UNITED STATES PATENT AND TRADEMARK OFFICE

APPLICATION NO.	FILING DATE	FIRST NAMED INVENTOR	ATTORNEY DOCKET NO.	CONFIRMATION NO.
09/764,473	01/17/2001	John W. Rocheleau	1296-015	8922

Office Action Summary

DETAILED ACTION***Claim Objections***

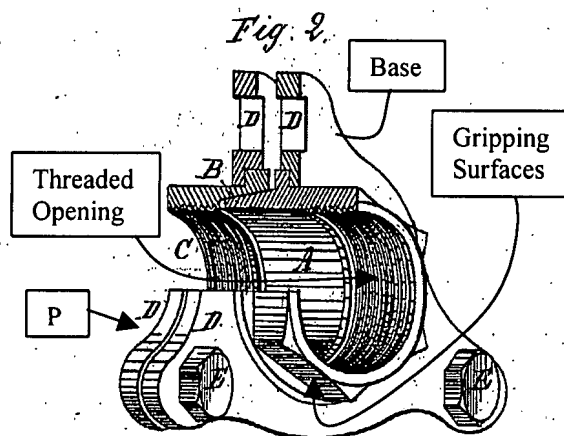
Claims 1-3 are rejected under 35 U.S.C. 102(b) as being anticipated by US patent 19818, Shaw. In figure 2 below, Shaw discloses a threaded pipe flange (P)

comprising a base portion

having a

predetermined shape and at least two openings (D) dimensioned to accept at least two mounting bolts; a shoulder portion (A) extending from and integral to the base portion, and the shoulder portion having two to six substantially flat gripping surfaces; at least two mounting bolts (E); and a threaded opening extending through the base and shoulder portion, and dimensioned for attachment to a predetermined threaded pipe. The pipe flange may be attached to a predetermined threaded pipe by aligning the threaded opening with the predetermined threaded pipe, gripping the gripping surfaces of the shoulder portion, and rotating the pipe flange.

Further, it has been held that the term "integral" is sufficiently broad to embrace constructions united by such means as fastening and welding. *In re Hotte*, 177 USPQ 326, 328 (CCPA 1973).

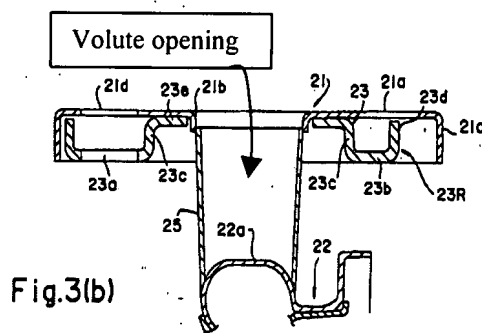
Claims 8 and 12 are rejected under 35 U.S.C. 103(a) as being unpatentable over US patent 5133642, Kajiwara, in view of Shaw. Kajiwara discloses on a pump (not shown, but "FIG. 4 is a sectional view...of a pipe joint at the discharge side of a pump"; column 3, lines 45-47); and in figure 3b below, one volute flange (21)

comprising a volute opening, and at least two bolt openings (21a, 21b). Shaw discloses a pipe joint as discussed above in regards to claims 1-3 having the aforementioned features; "the two nuts [Shaw, reference number A] are screwed or otherwise secured onto the ends of the [threaded and not shown] pipes to be joined" (Shaw, column 1, lines 23-25). It is well known in the art to use volute flanges of the type taught by Kajiwara, and pipe joints of the type taught by Shaw to form a piping system. It would be obvious to a person of ordinary skill in the art at the time the invention was made to use Kajiwara's volute flange and Shaw's pipe joint to form a piping assembly.

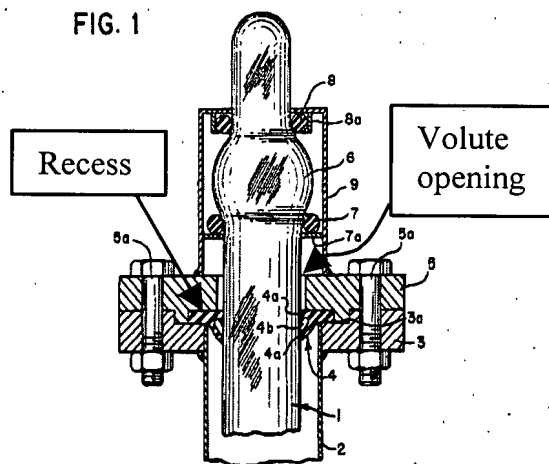
having a recessed portion surrounding the volute opening. In figure 1 below, Delahaye

discloses a gasket (4), volute flange (5), and a flat surface (3a) having a recessed portion surrounding the volute opening to provide a "leak proof" (Delahaye, column 2, lines 17-18) connection. It would be obvious to a person of ordinary skill in the art at the time the invention was made to provide a gasket and a volute flange with a flat surface having a recessed portion surrounding the volute opening to ensure a leak proof connection.
